Groundwater Transfer Review Summary Form

Transfer/PA # T- 14557 (RA)

Application: T-14557

Applicant Name: Joseph Cox & Hilary Rich

Well Location Map

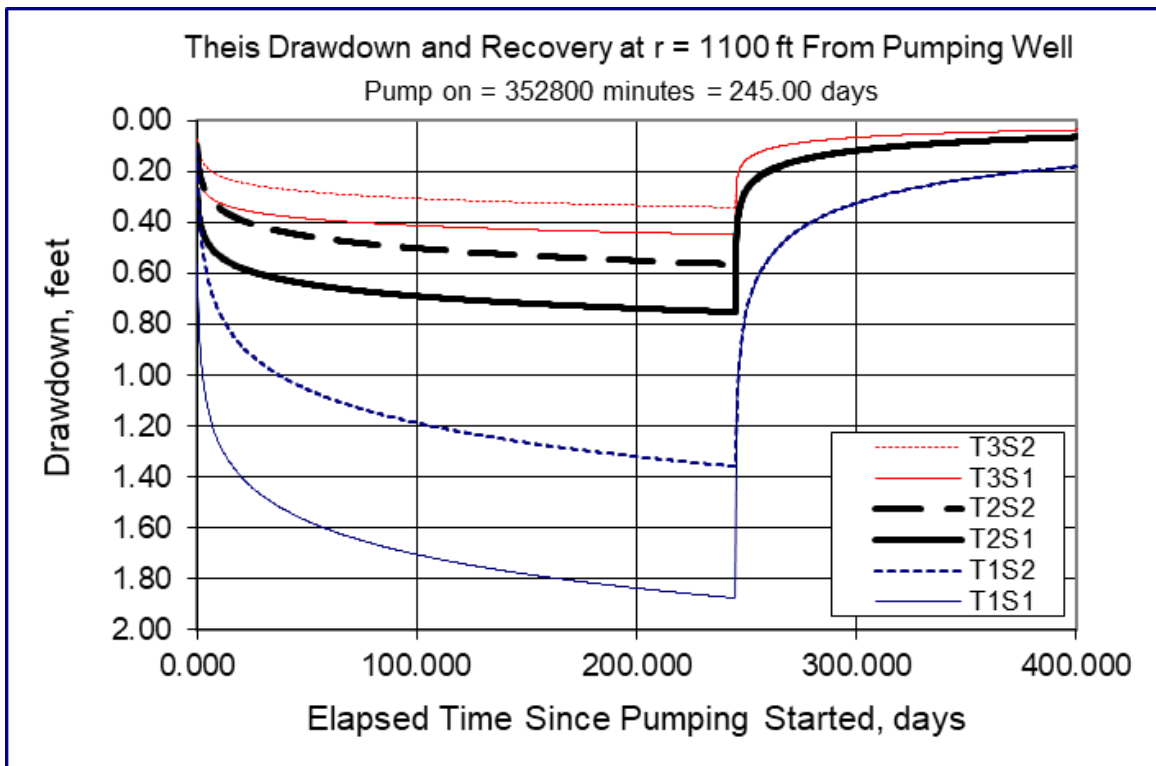
5. a) Will this proposed change, at its maximum allowed rate of use, likely result in an increase in interference with **another ground water right**?
 Yes No Comments: The proposed Hilary/Thomas well is ~1,100 feet from MARI 50132, and the proposed Joseph Cox well is ~1,650 feet from MARI 3232. These distances are 1,600 and 2,100 feet closer than the authorized POA Well 2 (MARI 69450) is to each of these existing wells, respectively. The closer proximity of the proposed POAs will likely increase interference with MARI 50132 and MARI 3232.

Estimated time-drawdown at MARI 50132 when pumping Hilary/Thomas Well at 0.225 CFS

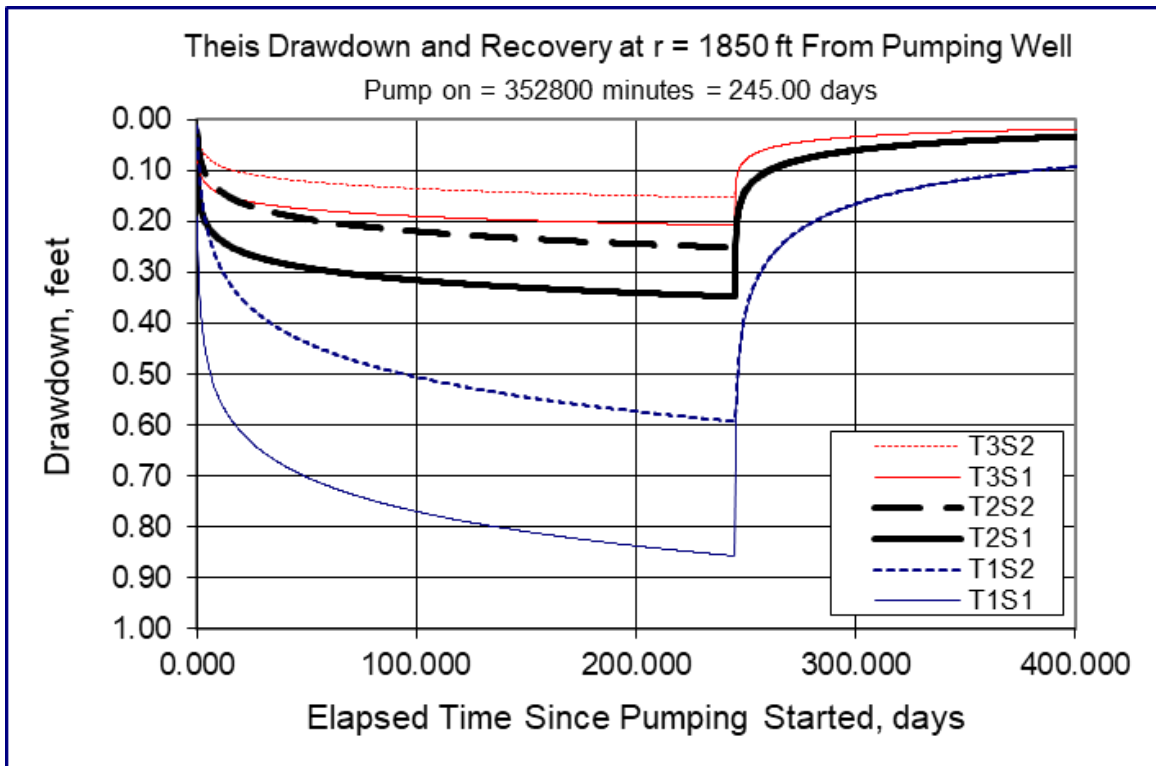
- b) If yes, would this proposed change, at its maximum allowed rate of use, likely result in another groundwater right not receiving the water to which it is legally entitled?
 Yes No If yes, explain: Under the proposed changes, the combined drawdown resulting from pumping at the maximum allowable rate from both proposed POAs would be less than 3 feet at either of the existing wells (MARI 50132 and MARI 3232). Given the thickness and high transmissivity of the Willamette aquifer in this area, the anticipated interference is not likely to cause injury to MARI 50132 or MARI 3232, or similarly-located neighboring water rights. 3 feet of drawdown is the maximum interference calculated using the most conservative hydraulic parameters. More details are listed in the **Theis Interference Analysis** section.
